| 8802-3/802.3 REVISION REQUEST 1228 |

DATE: 24th Jun, 2010
NAME: Marek Hajduczenia
COMPANY/AFFILIATION: ZTE Corporation
E-MAIL: marek.hajduczenia@zte.com.cn

REQUESTED REVISION:
STANDARD: IEEE 802.3av-2009
CLAUSE NUMBER: Annex 31C
CLAUSE TITLE: MAC Control organization specific extension
operation

Figure 31C-1—MAC Control EXTENSION Frame

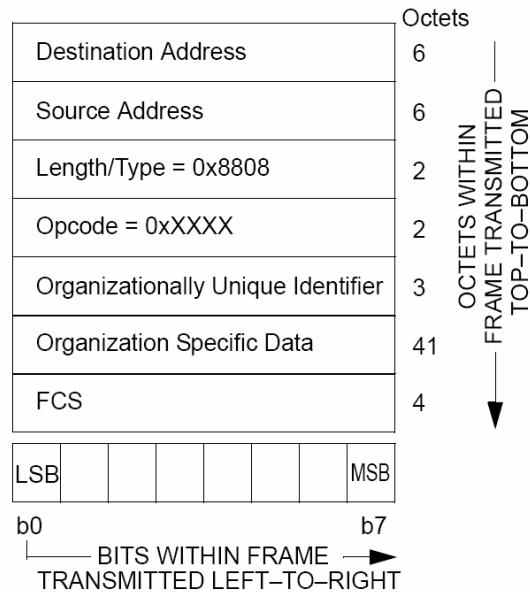
(3) Changes in '31C.3.1 Receive state diagram (INITIATE MAC CONTROL
FUNCTION) for EXTENSION operation'
(a) remove text '= 0x0019A7' in Figure 31C-1, field OUI
